SUBJECT: Application for amend to Licenses NPF-10 & NPF-15, consisting of Proposed Changes NPF-15-163, revising borated water source requirements & NPF-10/15-184, revising shutdown margin special test exception. Fee paid.

Subject: Docket Nos. 50-361 and 50-362
San Onofre Nuclear Generating Station
Units 2 and 3

DESCRIPTION OF PROPOSED CHANGE NPF-15-163 AND SAFETY ANALYSIS

Figure 3.1-1

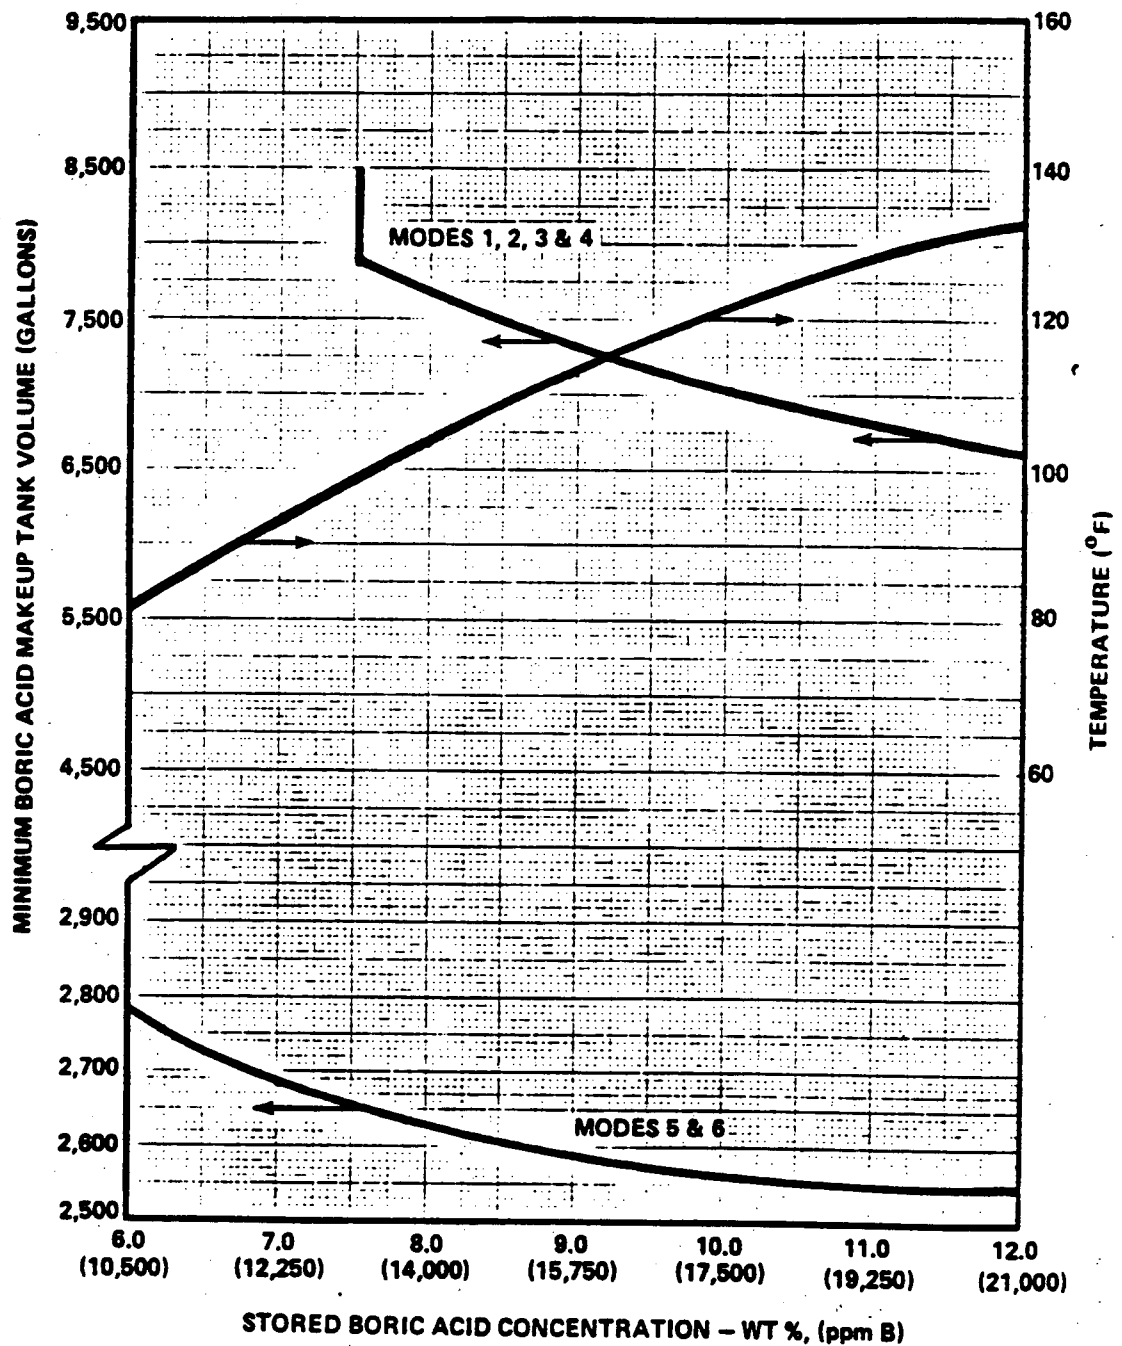
Modes 1 through 4 is set by the cold shutdown RCS boron concentration requirement (which is greater for the more reactive Cycle 2 core) and the pressurizer volume available for the pre-cooldown boration with letdown isolated (which is unchanged from Cycle 1). The minimum boric acid volume required in the BAMUT by Technical Specification 3.1.2.8 for Cycle 1, included both the initial boration volume and a portion of the cooldown makeup volume. For Cycle 2 operation, the cooldown makeup volume will be contained in the RWST; and the minimum boric acid volume required in the BAMUT will include the initial boration volume required to establish the Mode 5 Shutdown Margin. The combined effect of the increased boric acid concentration required for Cycle 2 operation and decrease in excessively conservative volume requirement, is a net decrease in the volume specified for operation in Modes 1 through 4, in Figure 3.1-1.

The maximum allowed boric acid concentration specified in figure 3.1-1 remains unchanged for Cycle 2. Therefore, the boron mixing demonstrated during the preoperational natural circulation test remains valid.
